Science and Technology Shortfalls in the National Missile Defense Program

Theodore A. Postol
Professor of Science, Technology, and National Security Policy
Security Studies Program, Massachusetts Institute of Technology
Voice: 617 253-8077; FAX: 617 258-5750; e-mail: postol@mit.edu

Washington, DC
Thursday 1 March 2001

Why the Specific Characteristics of the Signal from the Space-Targets is the Probable Source of the Kalman Filter Initialization Problems

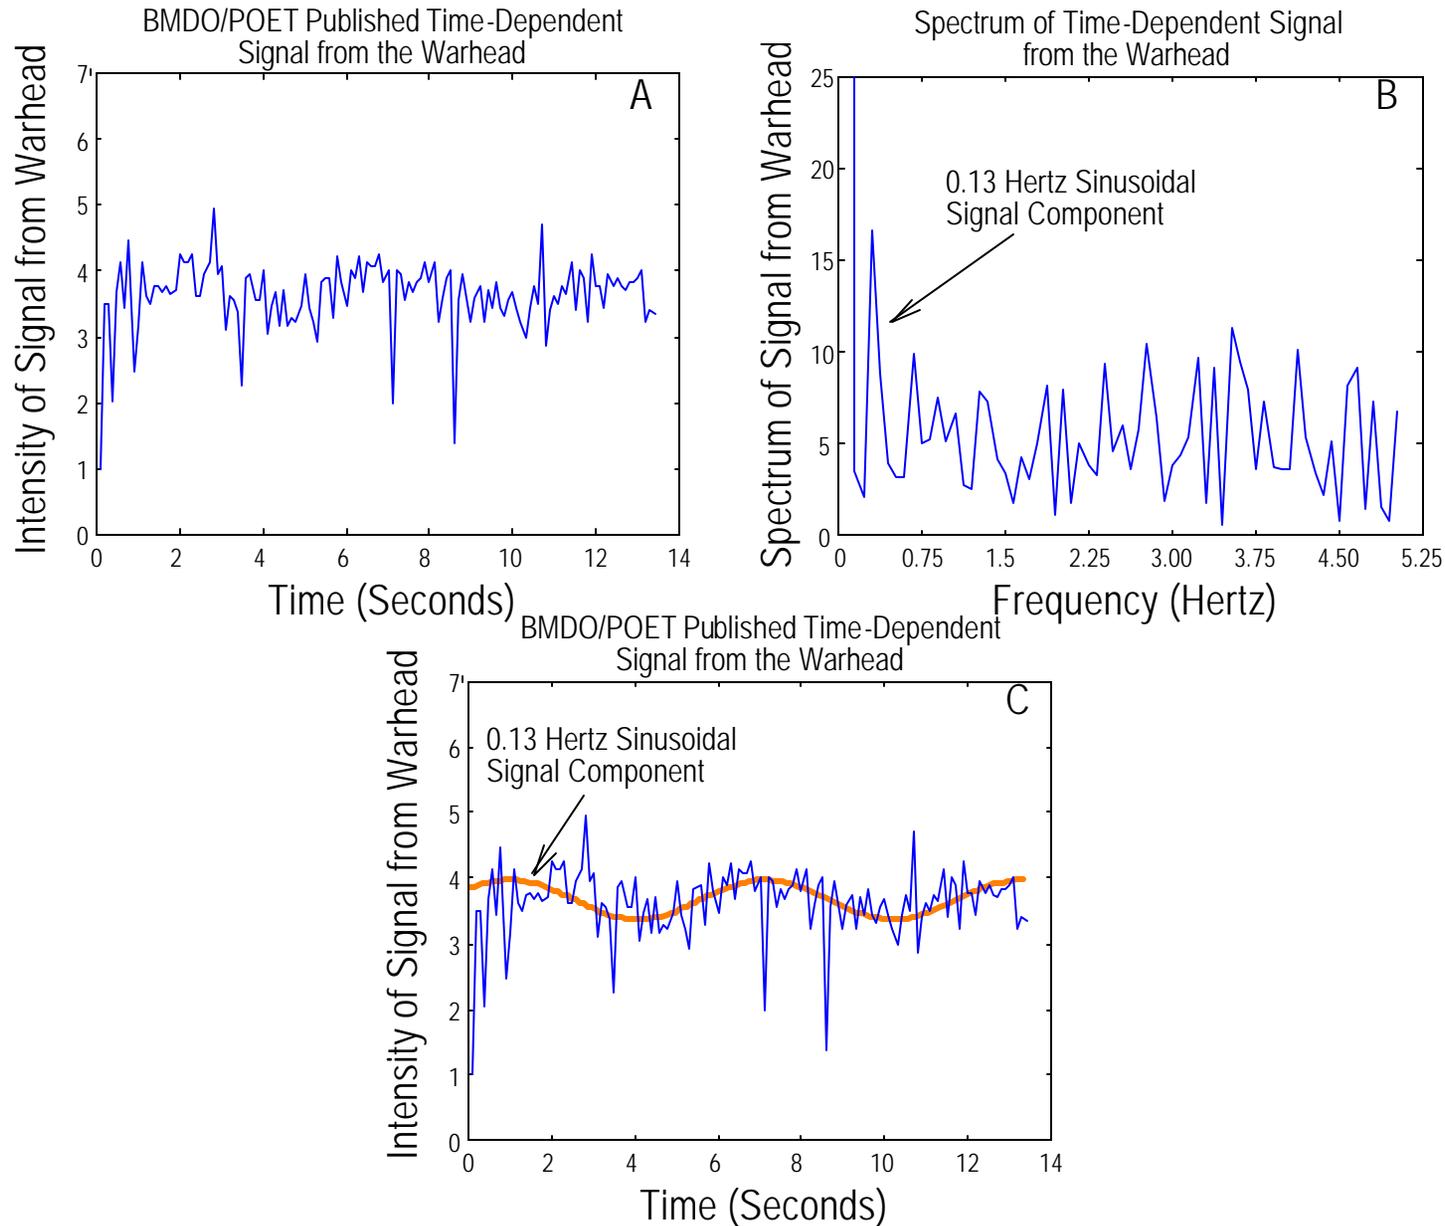
Simulated Noisy Two Band Intensity Signals—Used by the POET team to demonstrate the “Convergence” of the Kalman Filter.
Above graph from “*POET Study 1998-5, Independent Review of TRW Discrimination Techniques, Final Report,*” Figure 15, Page 33.

Spectral Content of the Signal from the Warhead In the Time Interval Between 1751 and 1768 Seconds

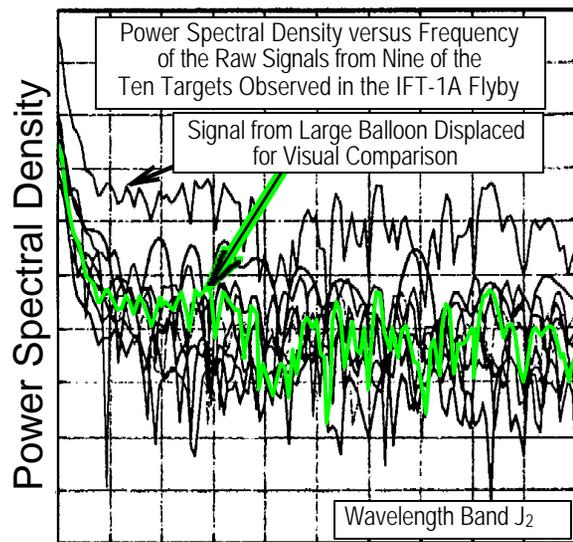
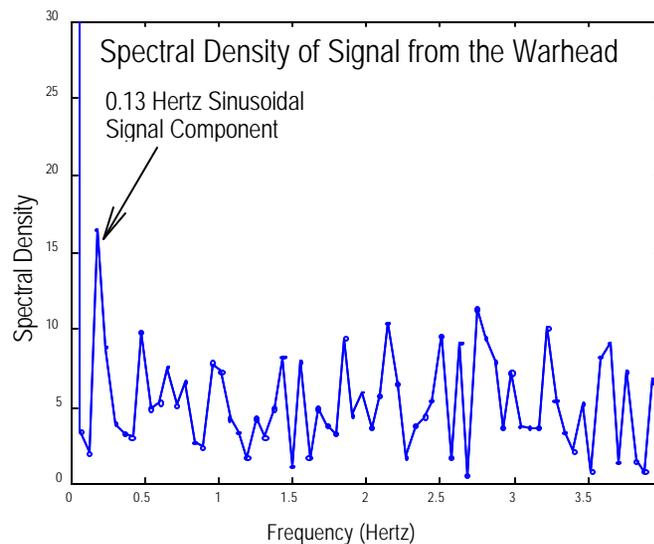
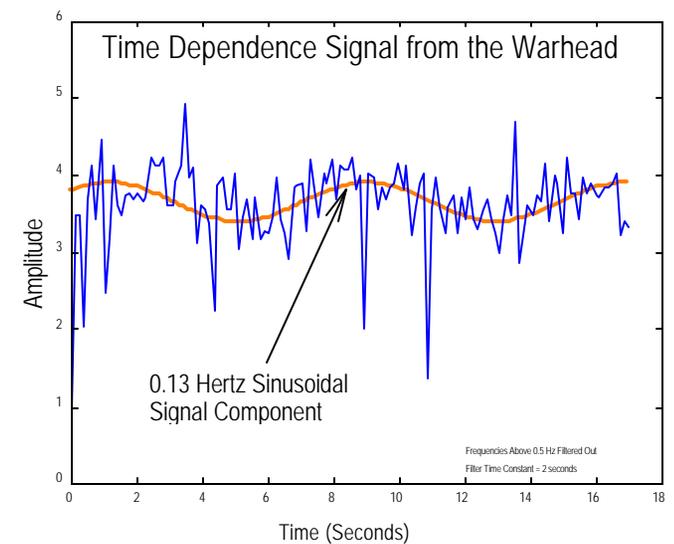
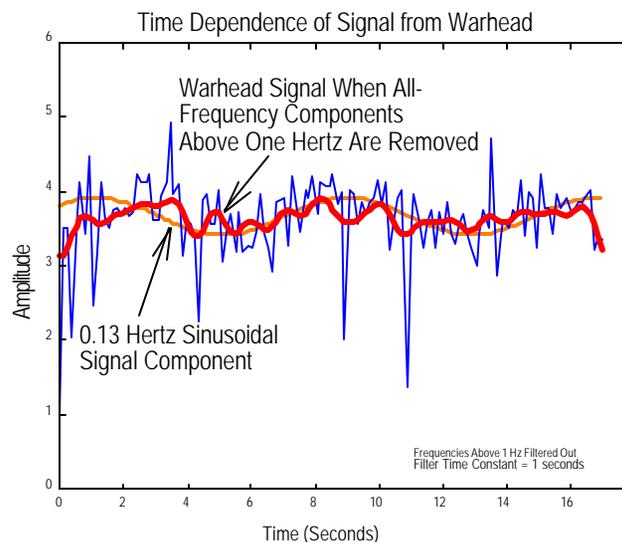
Power Spectral Densities from Targets Inconsistent and Show No Single Well-Defined Frequency

Rigging of the Test Program to Avoid the Simplest of the Baseline Threats

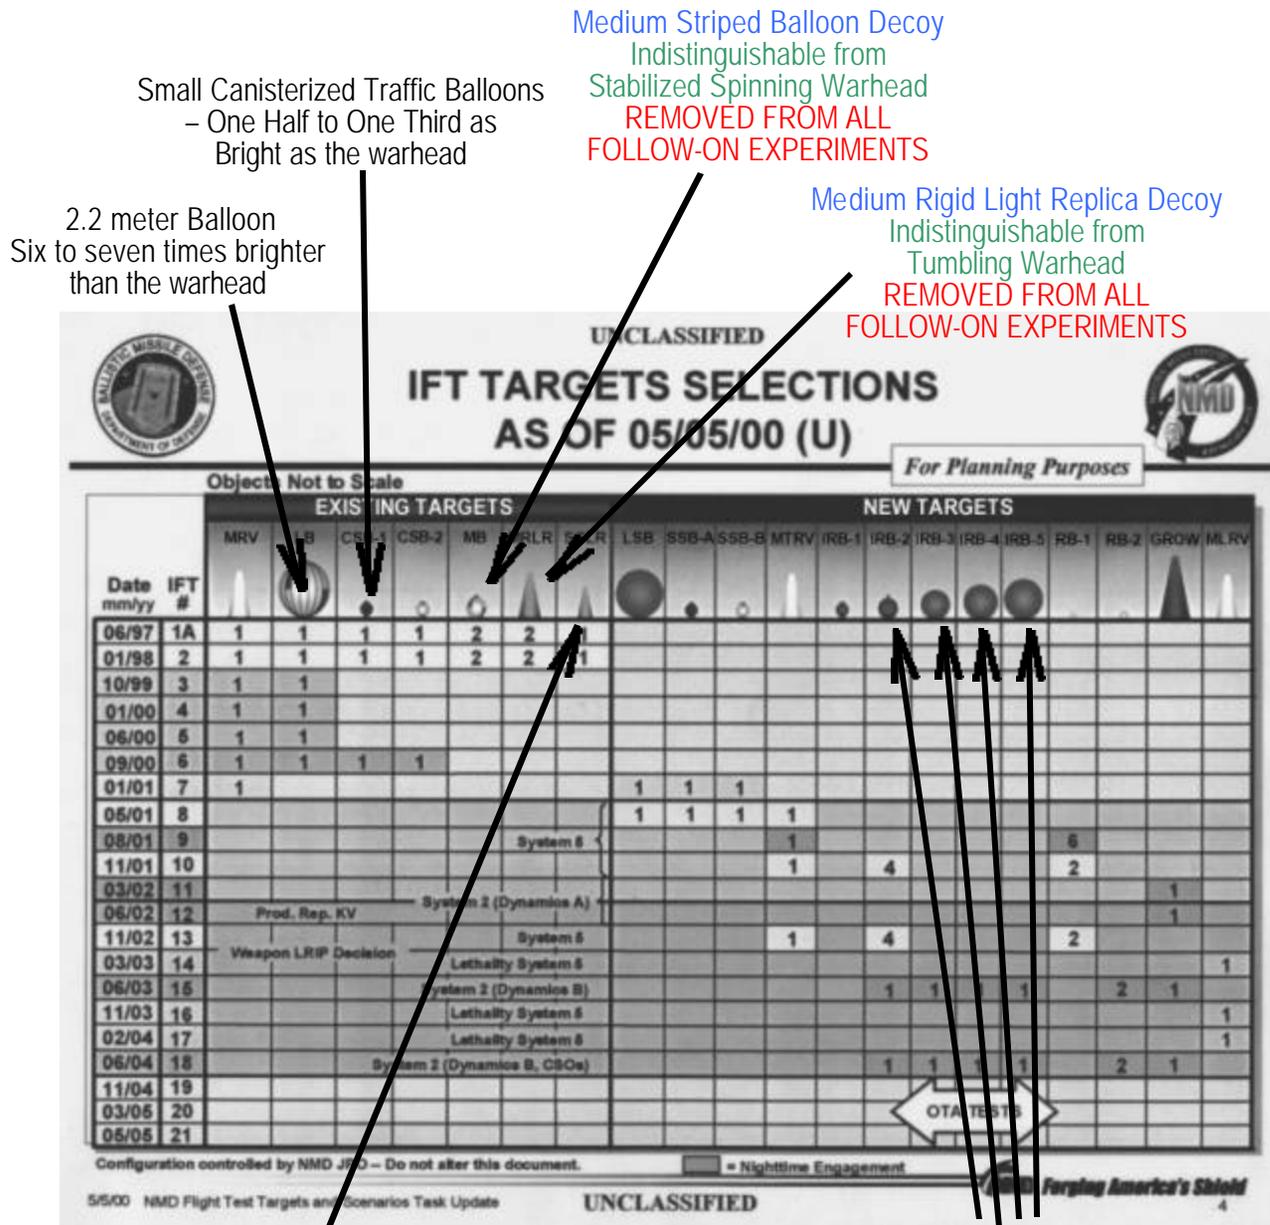
Scintillating Targets Removed from Test Program

Scintillating Stripes Removed

Scintillating Stripes Removed

Strongly Scintillating Tumbling Warhead

NMD Flight Test Program Viewed with Respect to the Results of the IFT-1A Experiment

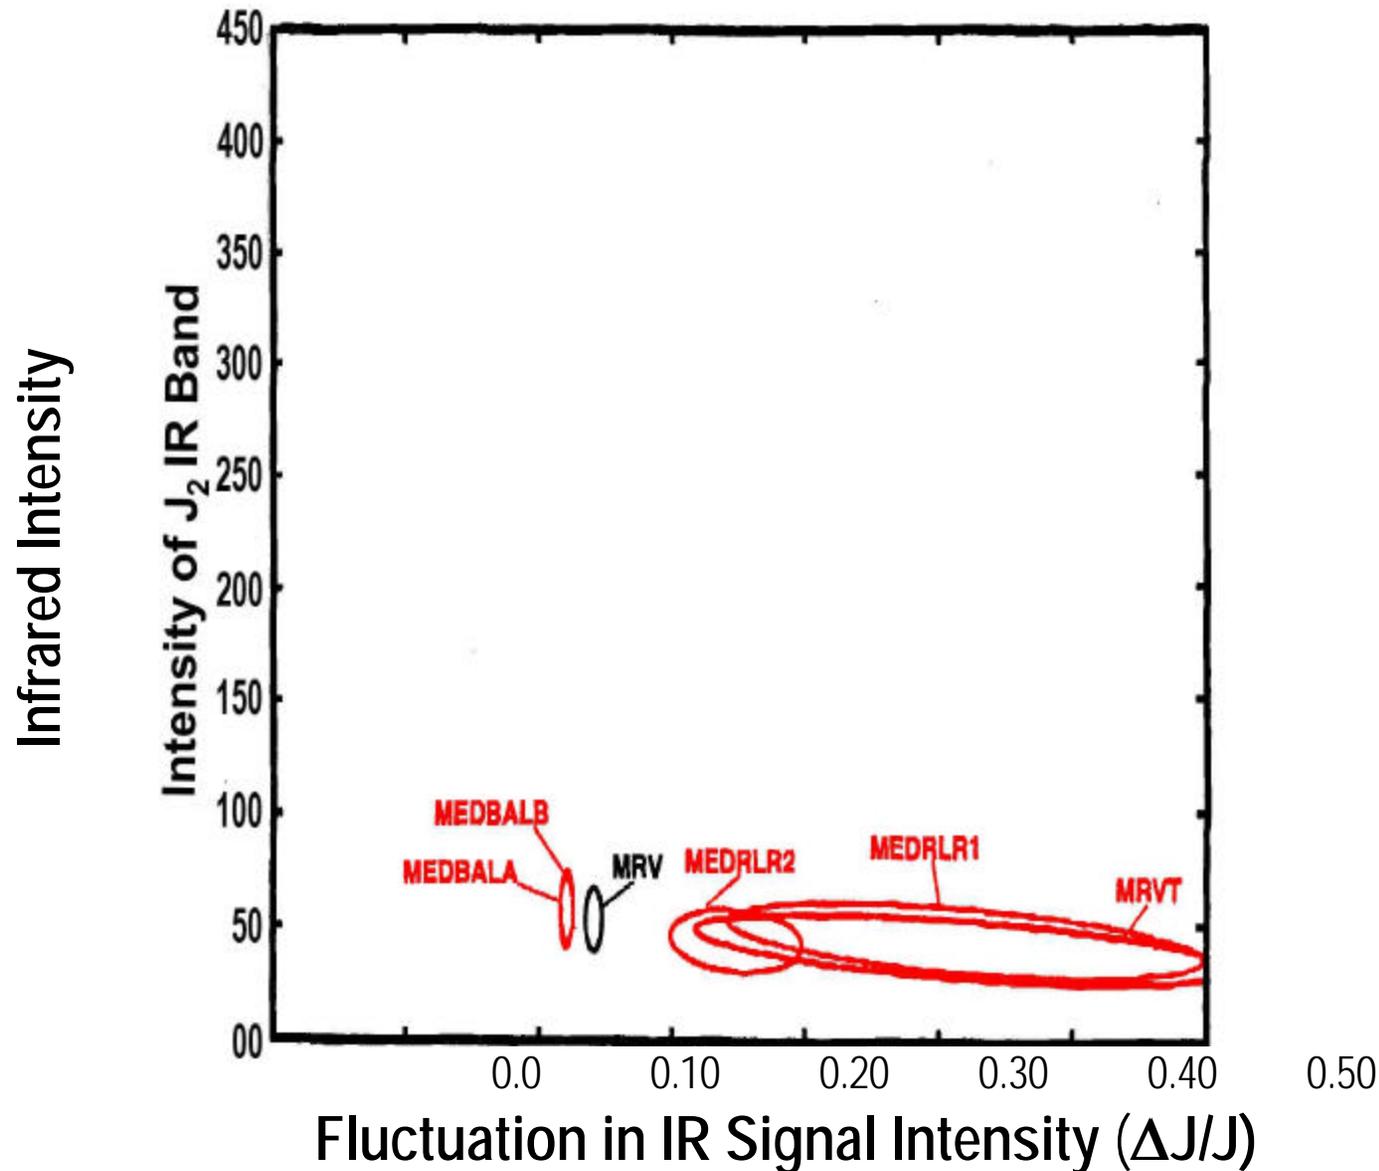
Small Canisterized Light Replica Decoy
Very Similar to Tumbling Warhead
REMOVED FROM ALL
FOLLOW-ON EXPERIMENTS

ALL NEW INFRARED DECOYS MODIFIED TO BE FEATURELESS SPHERES
SO THEY HAVE NO TIME-VARYING SIGNALS LIKE THOSE OF
THE NON-SPHERICAL SPINNING AND TUMBLING WARHEADS
